Town of Medway DESIGN REVIEW COMMITTEE 155 Village Street Medway MA 02053 (508) 533-3291

DRC Meeting Minutes Monday, August 1, 2022 Zoom (Remote) Meeting

Sign Design Review for The Hathon Apartments, 33 and 39 Main Street-

Review of revised site plan for Milford Hospital Medical Facility, 86 Holliston Street-

exterior monument sign

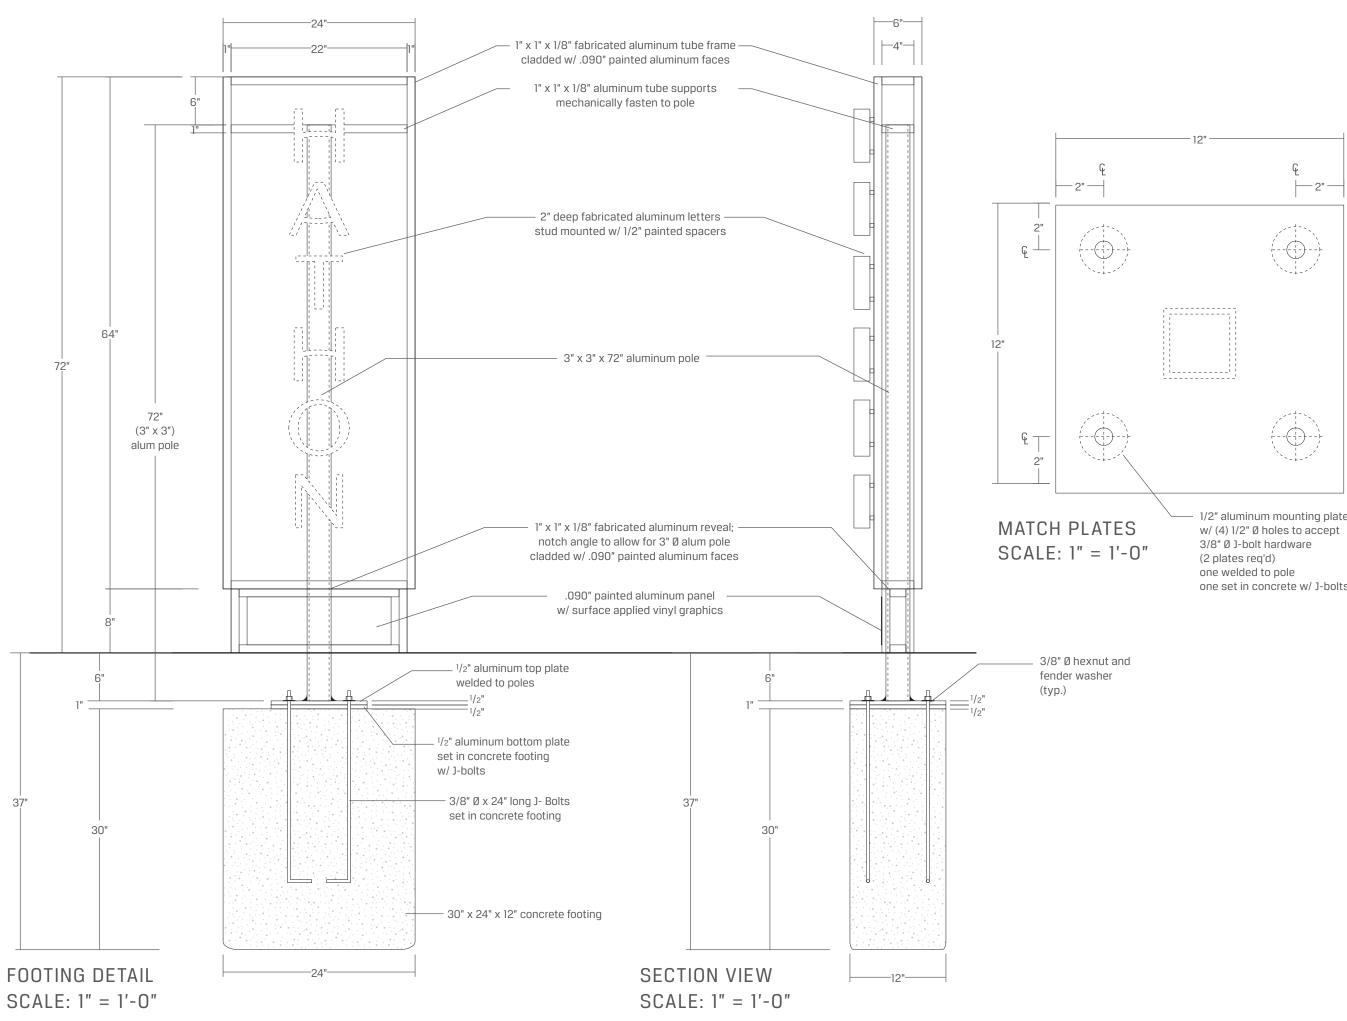
- The leasing sign size is reduced to 4 sq. ft.
- The monument sign size remained the same as proposed initially, 2' wide x 6' tall = 12 sq. ft. One sided facing Main Street. External spotlight is proposed for the monument sign; it will be centered to illuminate the entire sign.

Landscaping is proposed around the base of the monument sign. DRC members said the landscaping should include annuals and be professionally maintained.

- 1. This is a revised proposal.
- 2. Bylaw requires landscaping around the base of the sign 3' in all directions

leasing office mini monument

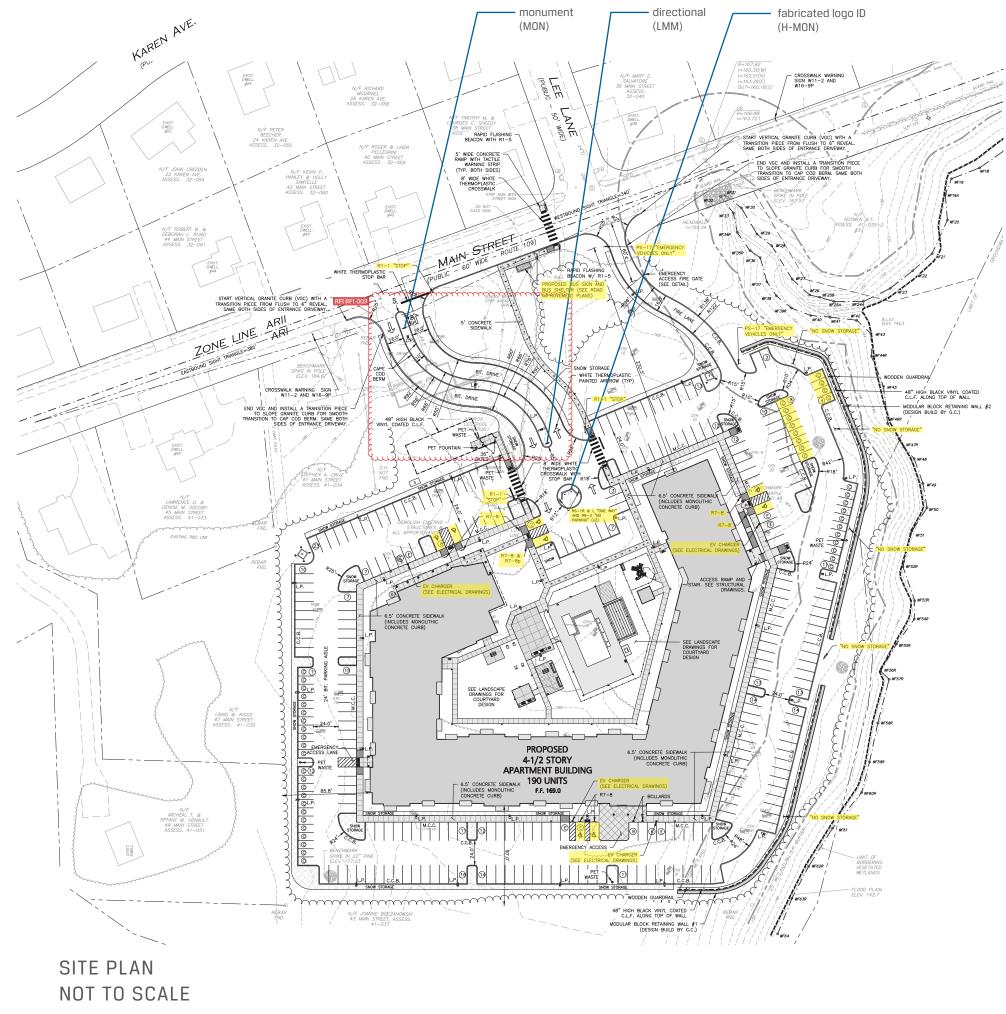
The location for the Leasing sign was adjusted to not conflict with the tree and was suggested to be brought closer to the entrance as indicated in the earlier plan version. Mr. Parillo will bring the comments to the owner so the plan can be revised. The alternative location (right of the

STOP sign) for the leasing sign location will be included in the DRC's review letter. Ms. Chabot agreed to draft the DRC's review letter.
